UNITED STATES PATENT AND TRADEMARK OFFICE

APPLICATION NO.	FILING DATE	FIRST NAMED INVENTOR	ATTORNEY DOCKET NO.	CONFIRMATION NO.
09/943,029	08/29/2001	Sang-Hyun Lee	19570-05384	9521
22918	7590	06/15/2005		
PERKINS COIE LLP P.O. BOX 2168 MENLO PARK, CA 94026			EXAMINER TORRES, JUAN A	
			ART UNIT	PAPER NUMBER
			2631	
DATE MAILED: 06/15/2005

Office Action Summary	Application No. 09/943,029	Applicant(s) LEE ET AL.	
	Examiner Juan A. Torres	Art Unit 2631

DETAILED ACTION

FIG. 1

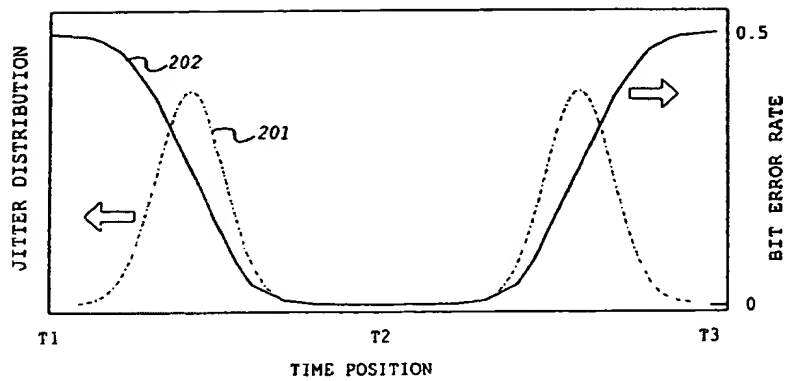
Figures 1 and 2 should be designated by a legend such as –Prior Art– because only that which is old is illustrated. See MPEP § 608.02(g). Corrected drawings in compliance with 37 CFR 1.121(d) are required in reply to the Office action to avoid abandonment of the application. The replacement sheet(s) should be labeled “Replacement Sheet” in the page header (as per 37 CFR 1.121(d)) so as not to obstruct any portion of the drawing figures. If the changes are not accepted by the examiner, the applicant will be notified and informed of any required corrective action in the next Office action. The objection to the drawings will not be held in abeyance.

FIG. 6

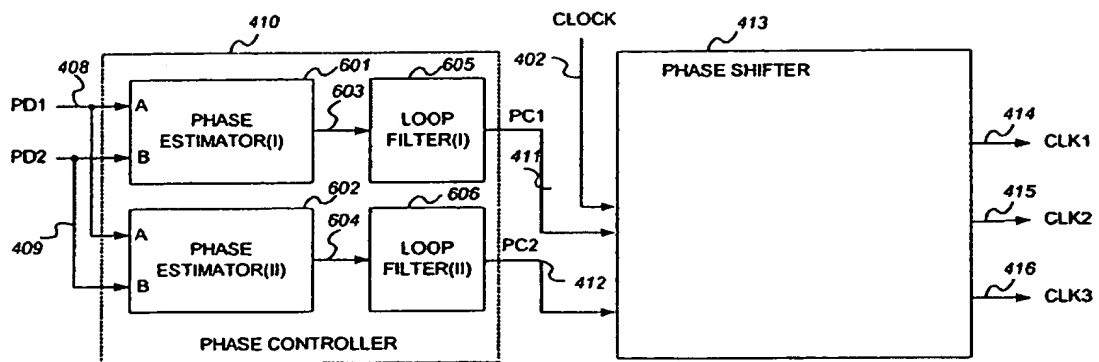
The drawings are objected to because FIG. 6 and FIG. 9 have not been printed correctly (it seems that the printer didn't have enough memory and some details that are in the original graphic have not been printed in the hardcopy, sometimes this problem can be fixed reducing the quality of the graphic at the time of printing). FIG. 6 is objected because: line 415 is not shown. FIG. 9 is objected because: Line 911 is not shown; line connecting block 911 with block 909 is not shown; line connecting block 901 with block 903 is not shown; line connecting label 903 with block "PHASE DISTRIBUTOR" is not shown. Corrected drawing sheets in compliance with 37 CFR 1.121(d) are required in reply to the Office action to avoid abandonment of the application. Any amended replacement drawing sheet should include all of the figures appearing on the immediate prior version of the sheet, even if only one figure is being amended. The figure or figure number of an amended drawing should not be labeled as "amended." If a drawing figure is to be canceled, the appropriate figure must be removed from the replacement sheet, and where necessary, the remaining figures must be renumbered and appropriate changes made to the brief description of the several views of the drawings for consistency. Additional replacement sheets may be necessary to show the renumbering of the remaining figures. The replacement sheet(s) should be labeled "Replacement Sheet" in the page header (as per 37 CFR 1.84(c)) so as not to obstruct any portion of the drawing figures. If the changes are not accepted by the

FIG. 7

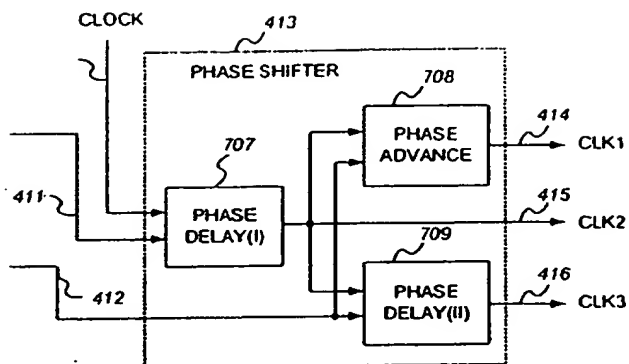
Page 13 paragraph [0033] line 3 block 411 is not shown in FIG. 7.
